VIRGINIA POWER
AMENDMENT TO OPERATING LICENSES NPF-4 AND NPF-7
NORTH ANNA POWER STATION UNIT NOS. 1 AND 2
PROPOSED TECHNICAL SPECIFICATION CHANGES

SAFETY EVALUATION FOR
REDUCTION IN BORON CONCENTRATION
IN THE BORON INJECTION TANK AND
CONCENTRATED BORIC ACID SYSTEM

NORTH ANNA POWER STATION
UNITS 1 AND 2

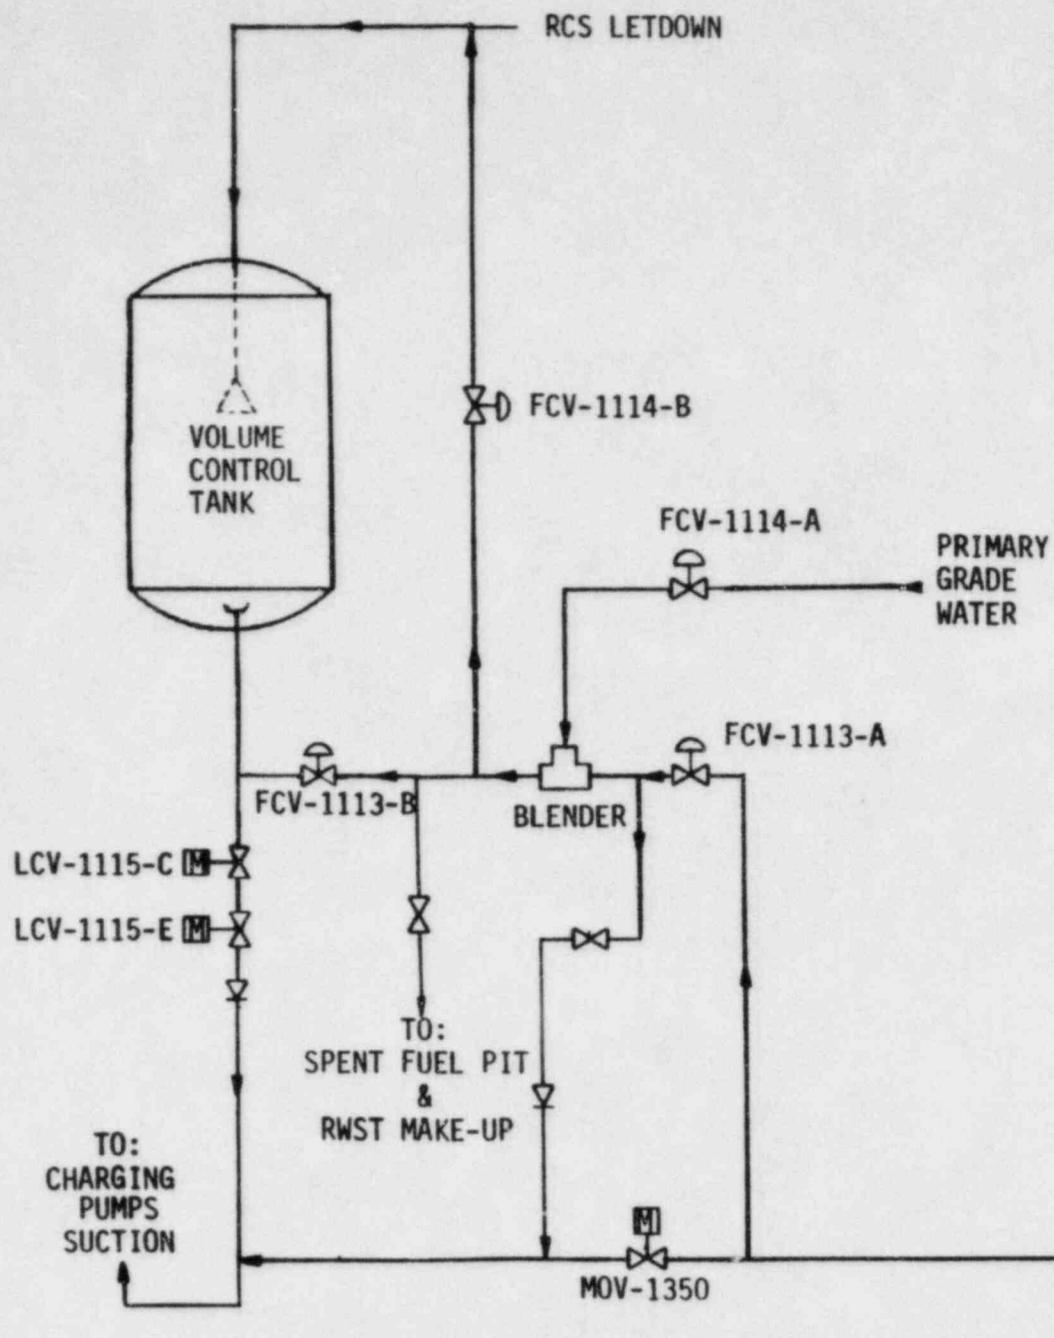
The Boron Injection Tank (BIT) is a 900 gallon carbon steel tank which is internally clad with stainless steel and is part of the Safety Injection System; it contains boric acid solution at a concentration of 11.5% to 13.0% by weight. Redundant tank heaters and line heat tracing are provided to maintain a minimum solution temperature at the Technical Specifications limit of 145 degrees F, thus preventing boron precipitation. Recirculation from the BIT to the Boric Acid Tank is maintained continuously via a Boric Acid Transfer Pump to ensure that the BIT is full of concentrated boric acid at all times and to prevent cold spots and stratification within the tank. The BIT is isolated from the Reactor Coolant System and the Charging Pumps during normal plant operation by two sets of parallel isolation valves. Figure 1 illustrates the system design as described above.

Current plans are to reduce the required boric acid concentration in the BIT to a range of 7.4 to 9.0% with no physical modifications to the plant.

FIGURE 2
 CONCENTRATED BORIC ACID SYSTEM
 NORTH ANNA UNITS 1 AND 2

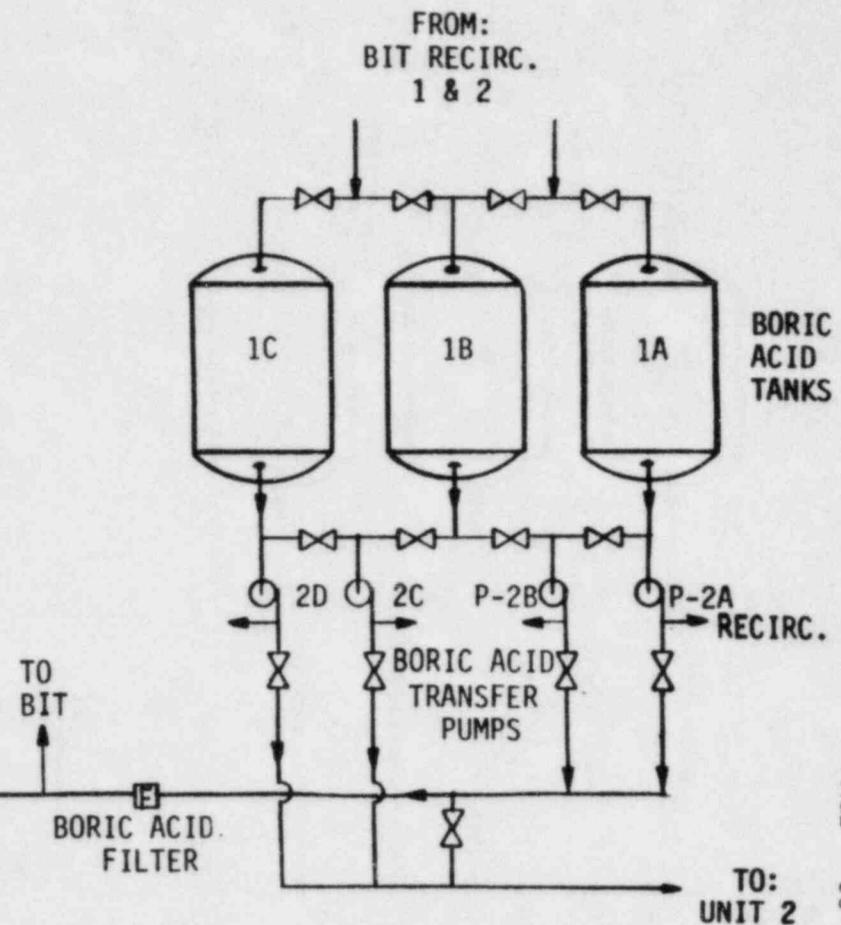
The concentrated boric acid system is a part of the Chemical and Volume Control System described in Section 9.3.4 of the Updated Final Safety Analysis Report. The purpose of the system is to provide an inventory of concentrated boric acid for (1) chemical shim reactivity control, (2) providing makeup to the Reactor Coolant System, Refueling Water Storage Tank, spent fuel pit and refueling cavity as necessary and (3) recirculation of boric acid through the BIT via the boric acid transfer pumps. The system is shared between the two North Anna units. It consists of three Boric Acid Tanks, four boric acid transfer pumps, one batch tank, boric acid filters and associated piping, valves, heat tracing, controls and instrumentation. The Boric Acid Tanks are sized to provide sufficient boric acid to bring both reactors to cold shutdown conditions assuming a stuck control rod. A simplified schematic of the system is shown in Figure 2.

A reduction in the boron concentration requirements for the Boric Acid System to a range of 7.4 to 9.0% will require increasing the minimum volume of boric acid stored for each operating unit to 6000 gallons. This can be accomplished by resetting the existing level instrumentation and alarms for the new minimum low level. With this increase in volume requirement for each unit, the capability to bring the units to cold shutdown conditions, with the most reactive control rod assembly withdrawn from the core, is preserved. BAT heater controls and the system heat tracing controls will be reset to maintain a minimum of $>115^{\circ}\text{F}$ to maintain solution solubility.

In summary, the proposed reduction in boric acid concentration will require the following:

1. Reset Boric Acid Tank Level instrumentation and alarms for a minimum volume of 6000 gallons.
2. Reset Tank heater and heat tracing controls to maintain a minimum solution temperature of $>115^{\circ}\text{F}$
